CITY OF ALBUQUERQUE

RE: **Covered Wagon**
13709 and 13705 Covered wagon Ave.
Grading and Drainage Plan
Engineers Stamp Date 8/29/16 (L13D014)

ENGINEER'S SEAL	COVERED WAGON SUBDIVISION-LOTS 5&6	DRAWN BY WCUJ
DAVID SOULE NEW MEXICO REGISTERED PROFESSIONAL ENGINEER 14522 8/29/16	GRADING AND DRAINAGE PLAN	DATE 7-29-16
	Rio Grande Engineering 1606 CENTRAL AVENUE SE SUITE 201 ALBUQUERQUE, NM 87106 (505) 872-0999	21511-LAYOUT-4-02-15
DAVID SOULE P.E. #14522		SHEET #
		JOB # 21510

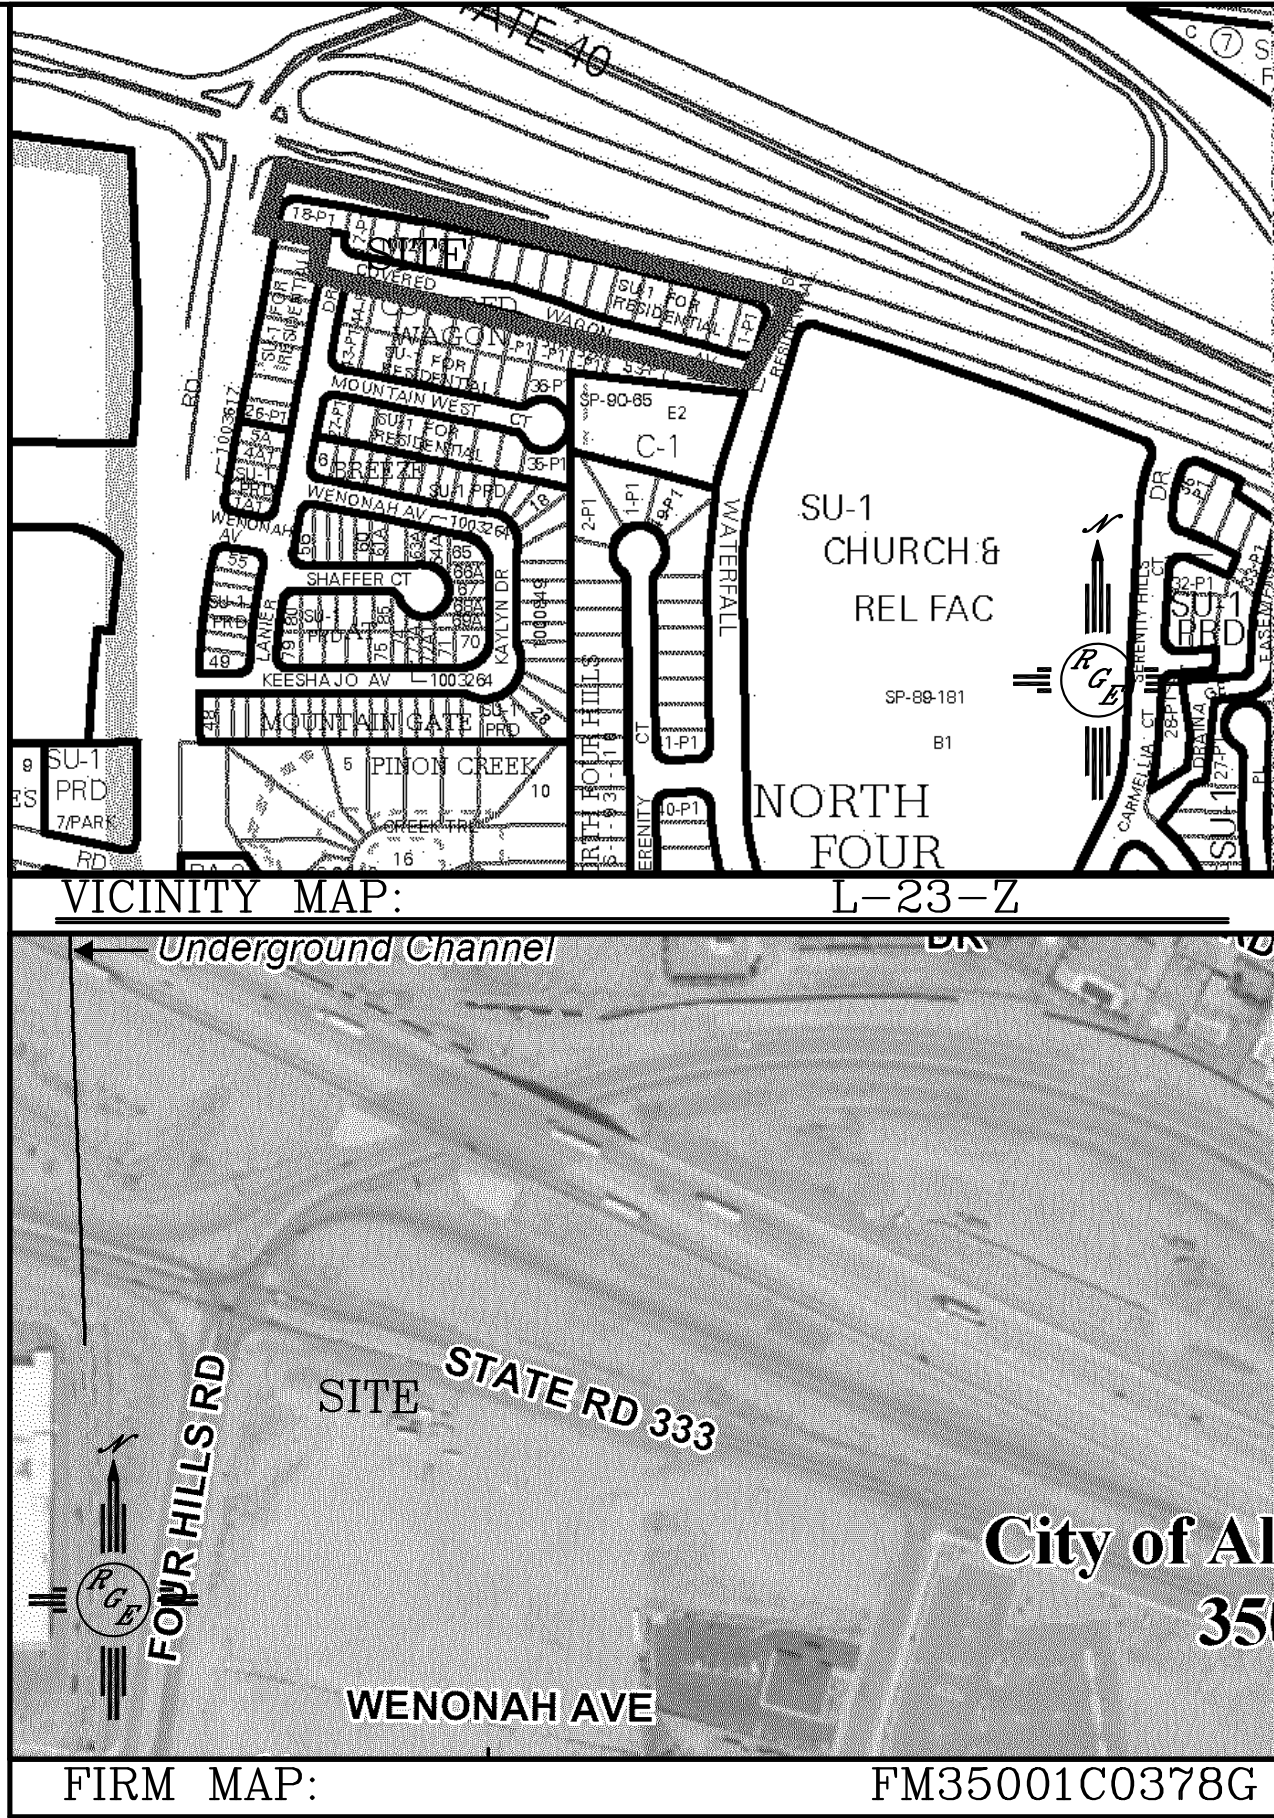
- An approved ESC plan is required for all the lots, plus an ESC Permit is required for each lot which have different owners.
An ESC has been approved
- Address the First Flush requirements. All flows must exit the front yard via a landscaped pond.
The first flush volume has been shown and pond added to the plan
- Provide how erosion will be prevented from entering the adjacent property.
Note number 4 has been added to the plan to address the conformance to the ESC
- Provide an excerpt about the retaining wall in the rear yards. Who will be responsible for the maintenance of the retaining wall?
As discussed on the phone, the wall was constructed under work order
- Was the retaining wall in the rear yards approved and certified?
The wall was approved and certified under previous work order.
